# LAKE HAVASU CITY

### ADDENDUM NO. 1

2015/16 Water Main Replacements  
Project No. WT3080

**DATED: OCTOBER 11, 2016**

Detail 2 on Sheet 34 shall be replaced in it’s entirety with the following:

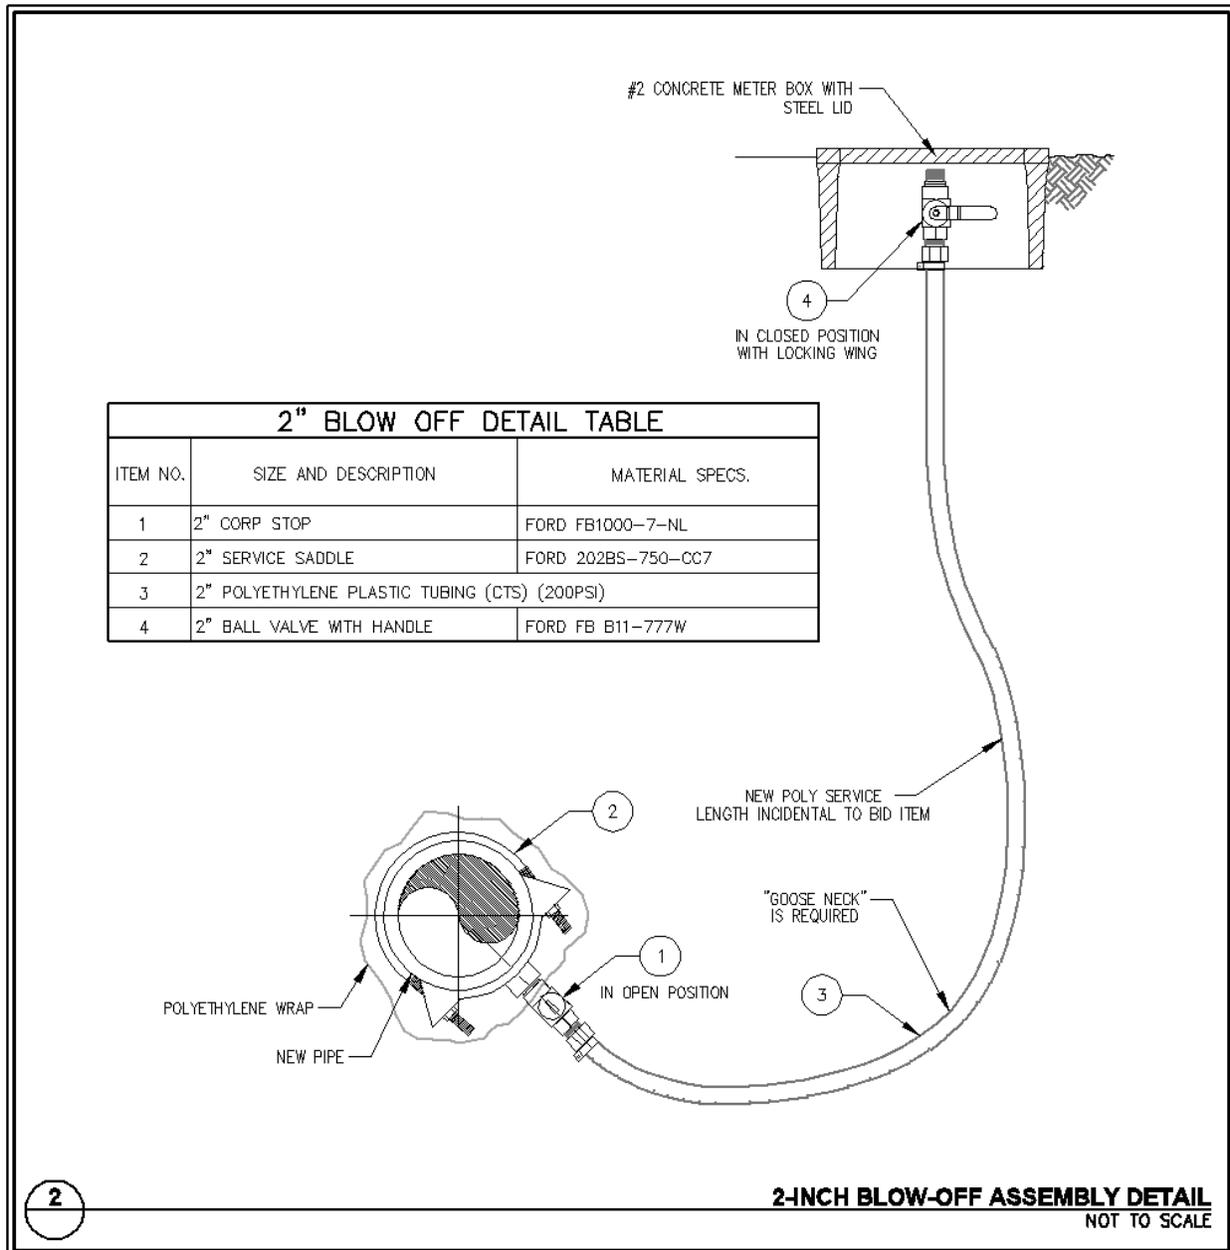
**Answer:** Not at this time. Substitutions will be considered during the submittal process in accordance with Specification 00700, Section 10.0.
- 10. Question:** *“Detail 2 on Sheet 34, the corp stop shown is intended to be used for a single flow direction only, can a Ford Ball Valve FB B11-777W be used in lieu of the corp-stop within the meter box as it will most likely fail and leak?”*

**11. Question:** *“Detail 2 on Sheet 34, would the City consider using Ford Saddle Style S91 in lieu of the spec’d Ford 202BS?”*

**Answer:** Yes, the Contractor’s attention is directed to Item 7 below.

**Item No. 7 –**
